PZ&B Staff Combination Memorandum: Architectural Commission (ARCOM) and Town Council

SUBJECT: ZON-22-0014 (ARC-24-0022) 1246 N LAKE WAY (COMBO)

MEETING: AUGUST 28, 2024, ARCOM
SEPTEMBER 11, 2024, TC

PREVIOUSLY PROPOSED SOUTH ELEVATION

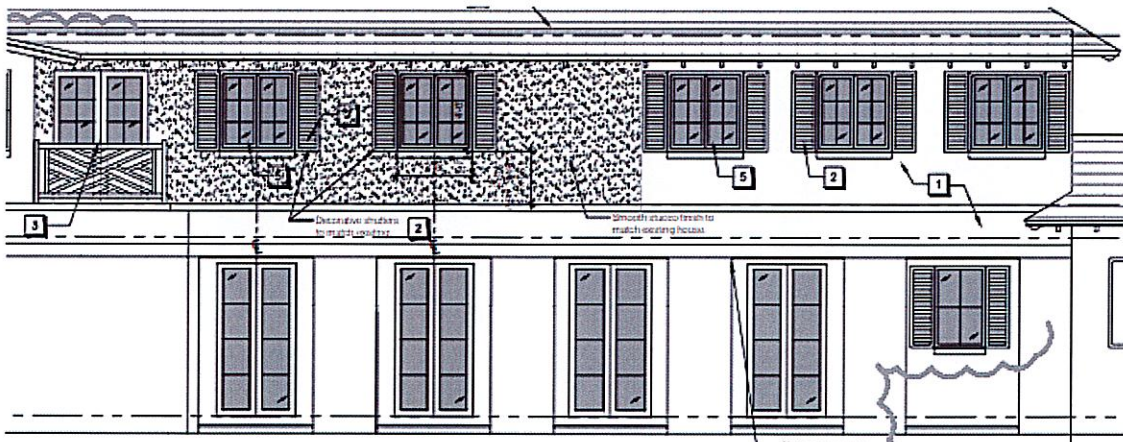
Following the deferral at the July hearing, the applicant has refined the proposed palette and material selections, aligning with the feedback provided. The previously approved shutter color, "Raccoon Fur" by Benjamin Moore, has been substituted with a more historically aligned tone, "Colonial Blue," also by Benjamin Moore. Additionally, the treatment of the window and door frames has shifted from the initial proposal of paint to white oak stain, harmonizing with the garage and front doors.

PREVIOUSLY PROPOSED EAST ELEVATION

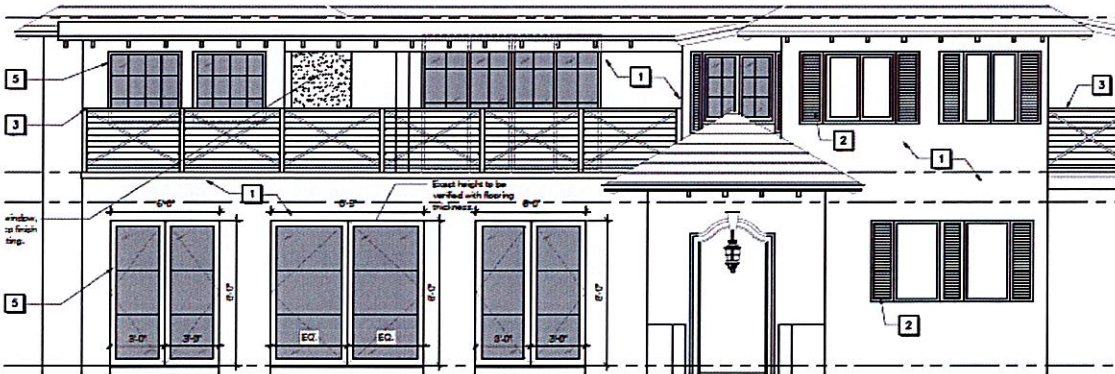
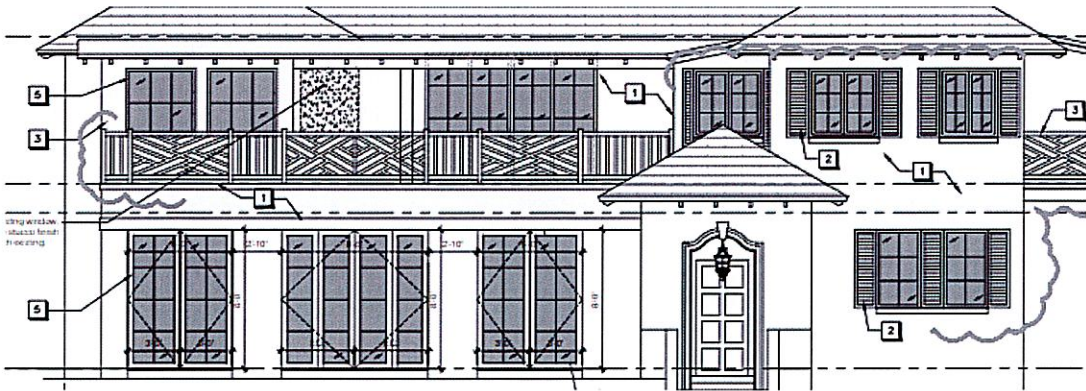
The east elevation now features the introduction of horizontal muntins on the nano door, contributing to a visually integrated design language. The balcony railings have been modified, moving away from the prior 42-inch white cross design to a more elegant and proportionally balanced 36-inch white Chippendale motif, providing a subtle yet distinguished architectural enhancement.

1. Applicant shall retain the arches on the first floor at the open loggia and new enclosure on the east.
2. Applicant shall remove the shutters above the front door.
3. Sconces shall be revised.
4. Applicant shall submit an administrative application with all required revisions to be reviewed by the ARCOM Chair.
